2. Revisions to the Draft EIR

The following section provides minor revisions or corrections to information presented in the Draft EIR. The changes to the Draft EIR presented in this section do not represent substantial revisions to the information presented in the Draft EIR that was circulated for public review. No new significant project impacts have been identified since the Draft EIR was distributed for review.

Project Description Changes

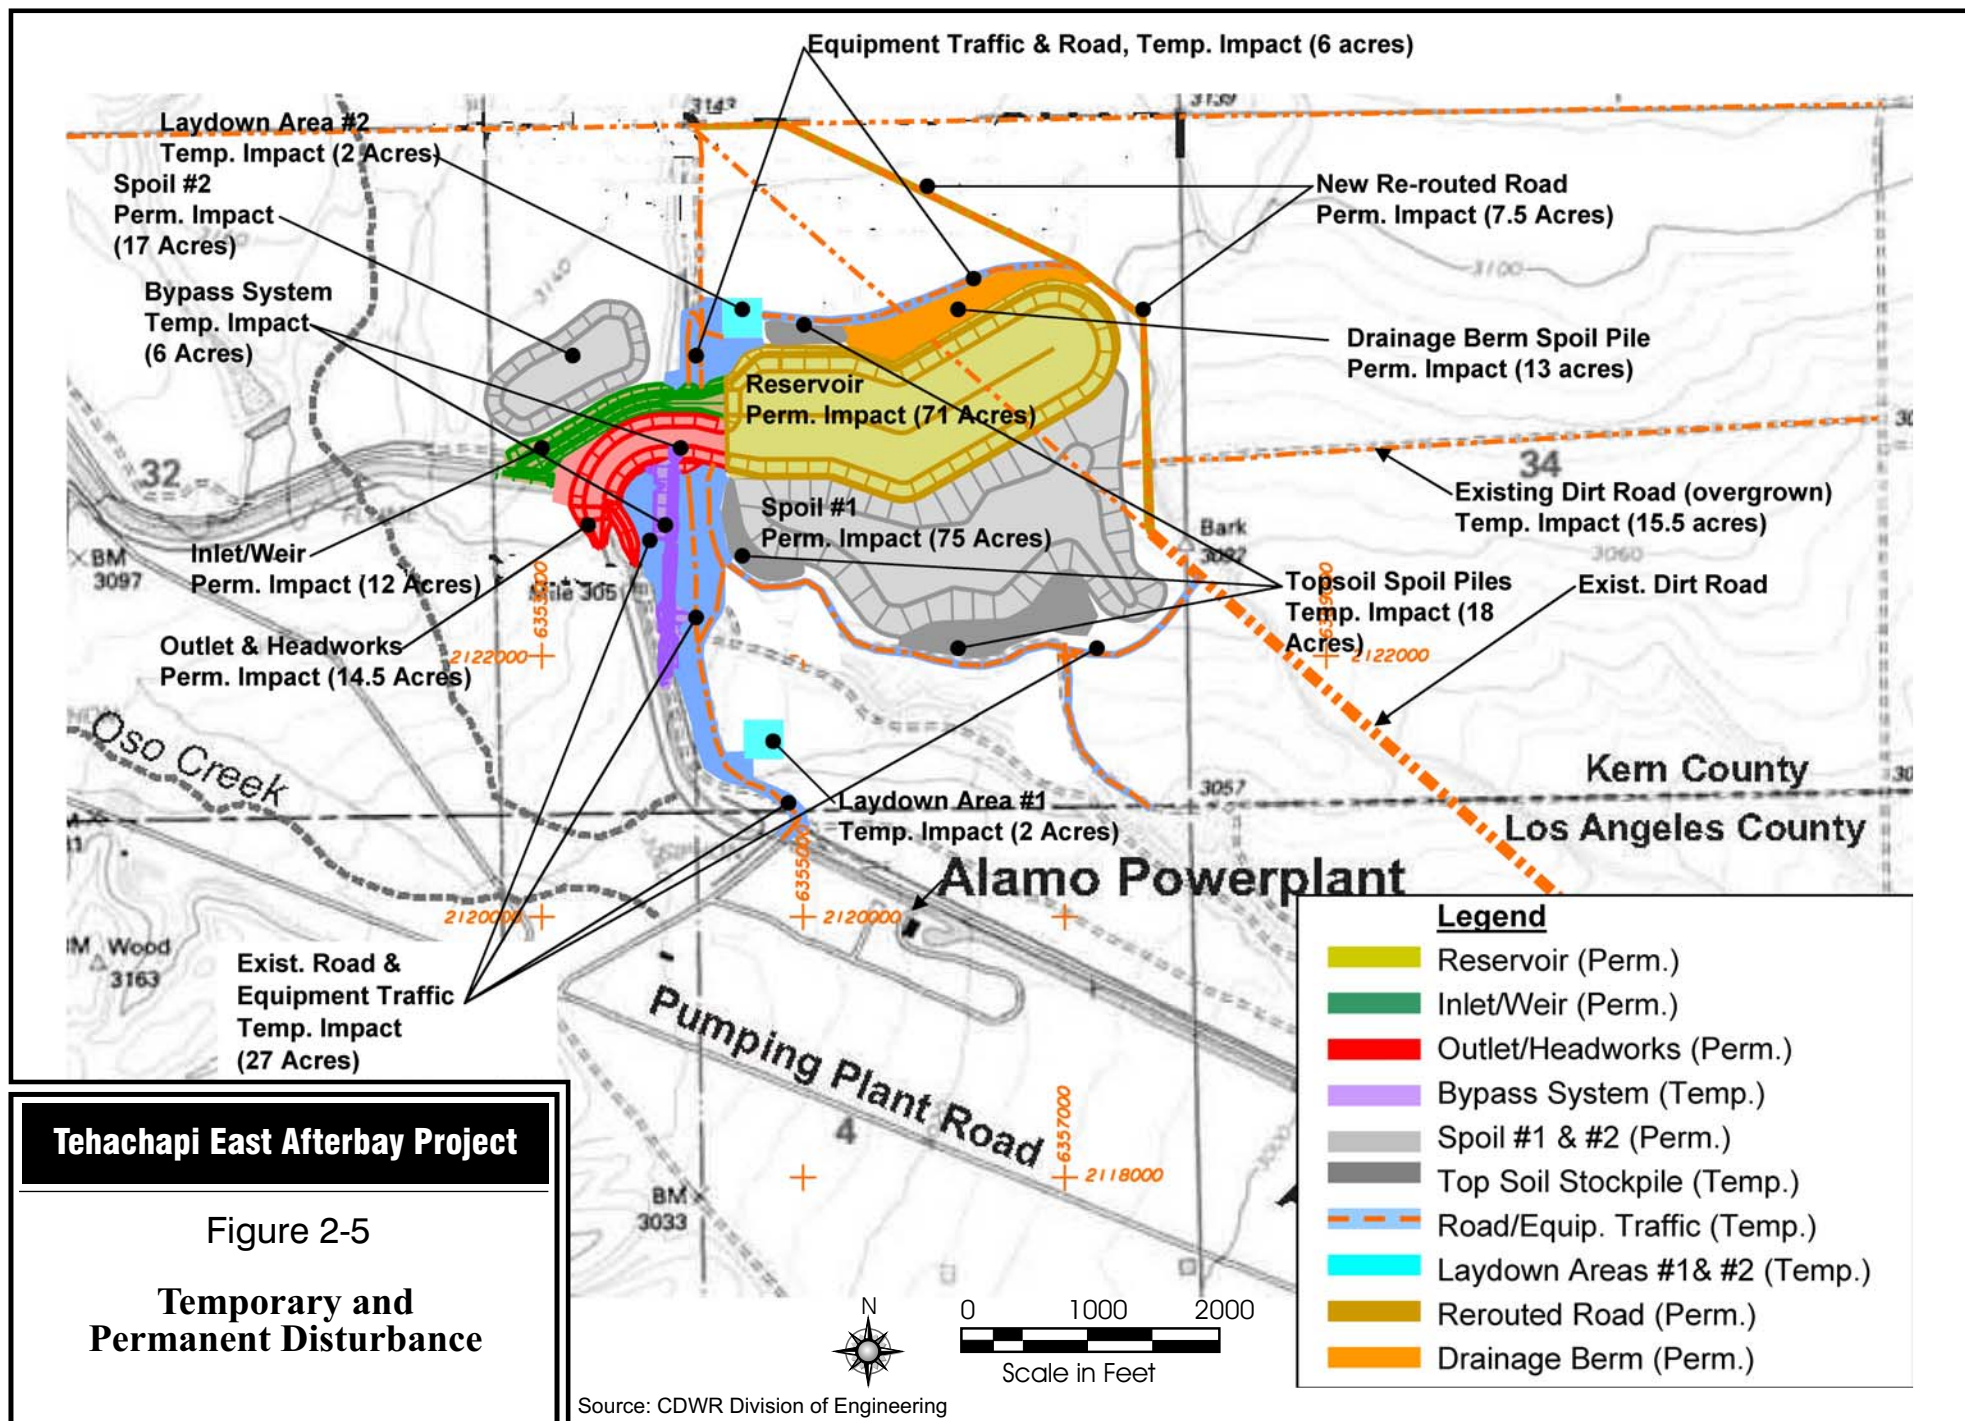
Figure 2-5 on page 2-13 has been updated based on the project design changes discussed above (see Project Description Changes). Rock slope protection has been removed from the project design, the bypass system is now shown as a temporary impact, and a drainage berm spoil pile has been added north of the reservoir area and identified as a permanent impact.
